Addendum No. 1

Contract No.: DA00330

Replacement of Existing Pipes / Culverts in Chowan and Perquimans Counties

ADDITIONAL CULVERT UNDERCUT:

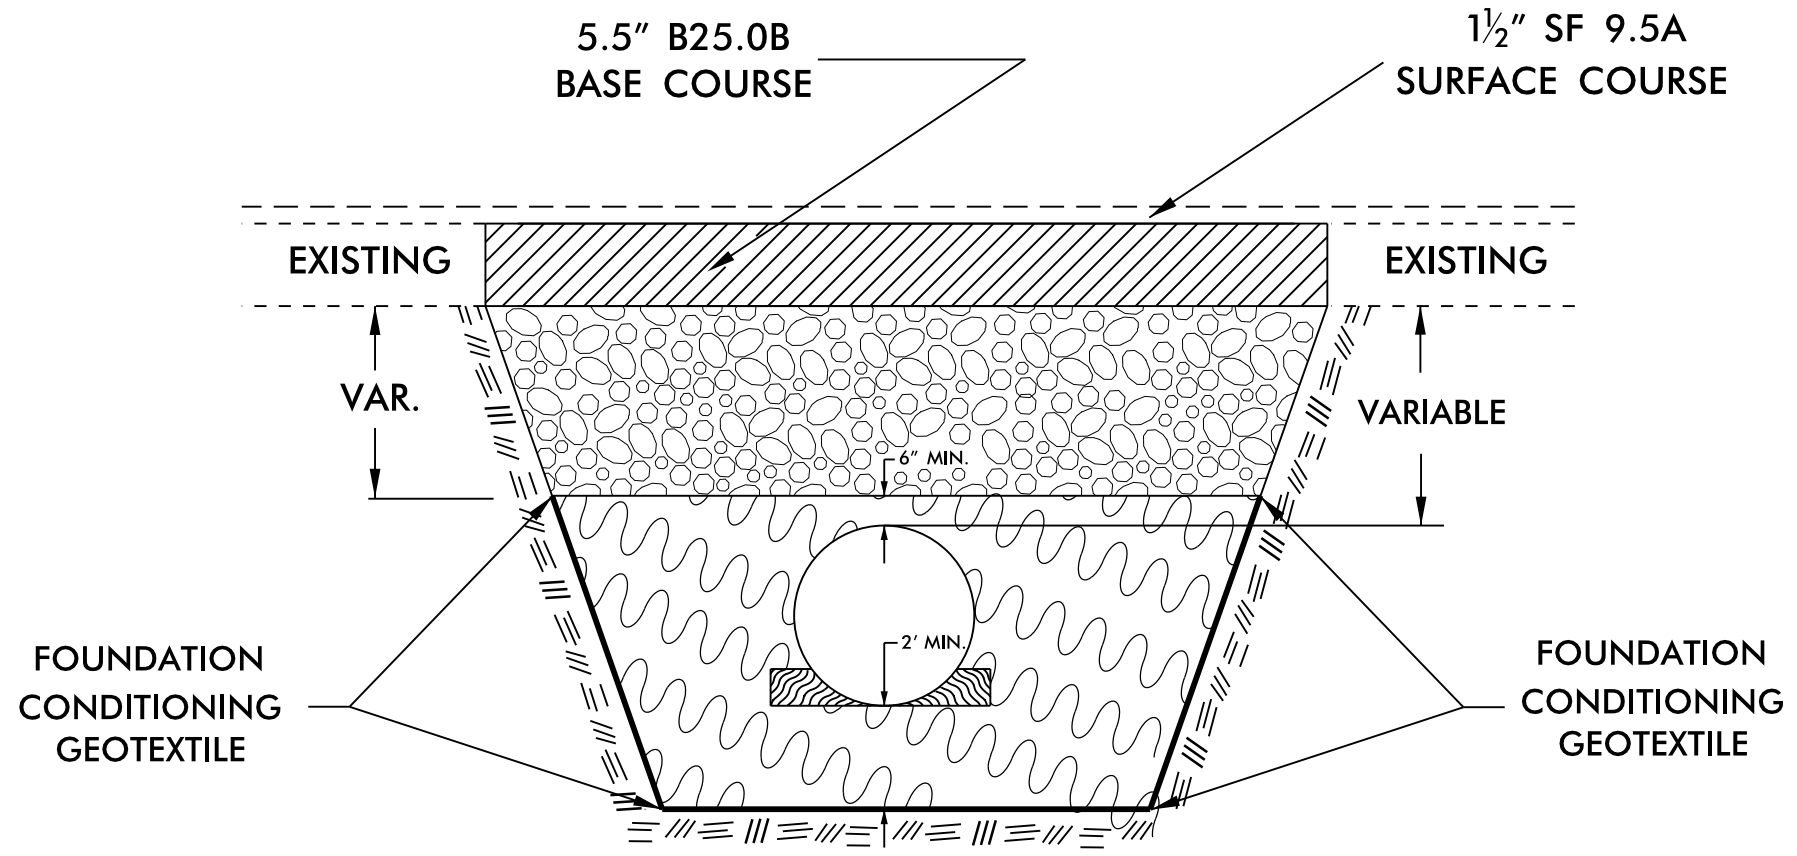
Page No.68 "Additional Culvert Undercut" has been revised to clarify the depth requirements. Please void existing Page No. 68 and replace with revised Page No. 68.

Any undercut beyond the specified 2' below pipe bed, that is out of the Contractor's control and as directed by the Engineer, will be paid for at the contract price as *Generic Culvert Item (Additional Culvert Undercut)* by the cubic yard which will be full compensation for all items required for additional undercut.

INSTALLATION DETAIL

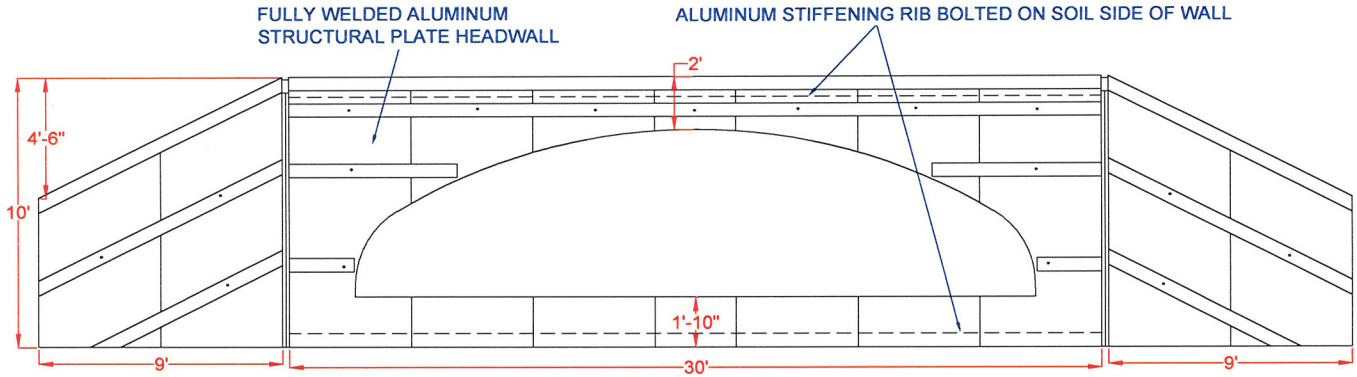
Plan Sheet "Installation Detail" the detail has been revised to clarify the foundation conditioning material and to illustrate the geotextile fabric requirements. Please void the existing Plan Sheet "Installation Detail" and replace with the revised Plan Sheet "Installation Detail".

SELECT MATERIAL CLASS VI FOR FOUNDATION CONDITIONING MATERIAL
ENGINEERING FABRIC WILL BE INSTALLED BELOW THIS MATERIAL AS DIRECTED BY THE ENGINEER

DESCRIPTION	
NCDOT CHOWAN CO NC-32	
FIRM:	
PROJECT:	
DATE: OCT 28, 2016	SHEET
NOT TO SCALE

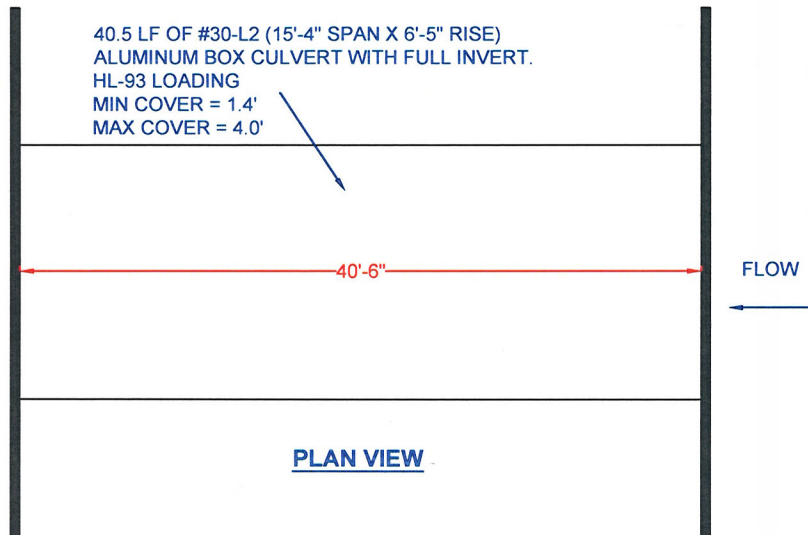
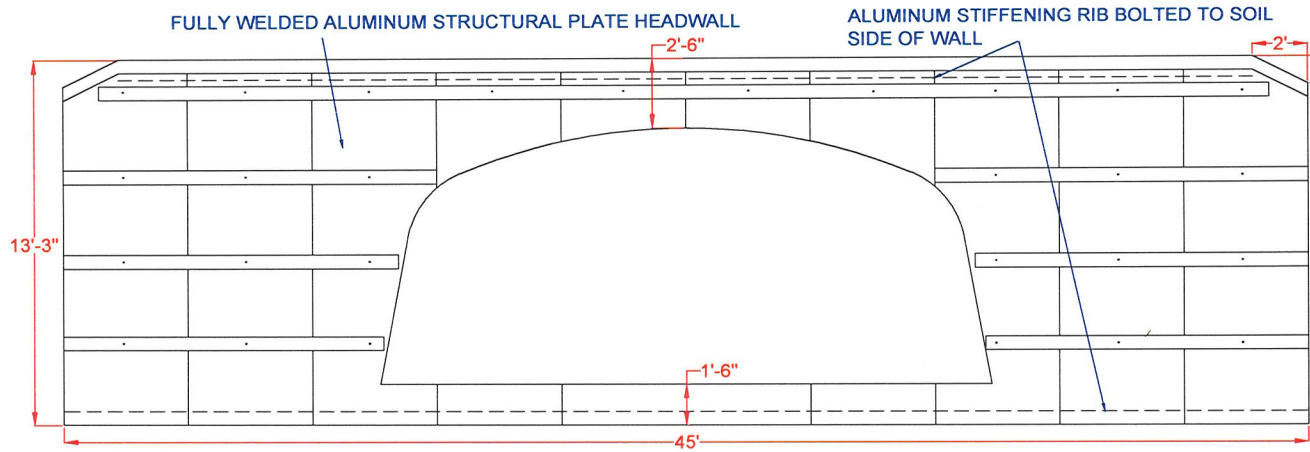
****REVISED STRUCTURE SIZE
DUE TO HEIGHT OF COVER**

- TOP ∇ ROAD= 100.00
- TOP OF WALL= 98.91
- TOP OF STRUCTURE= 96.41
- INV. OF STREAM= 91.00
- INVERT OF STRUCTURE= 90.00
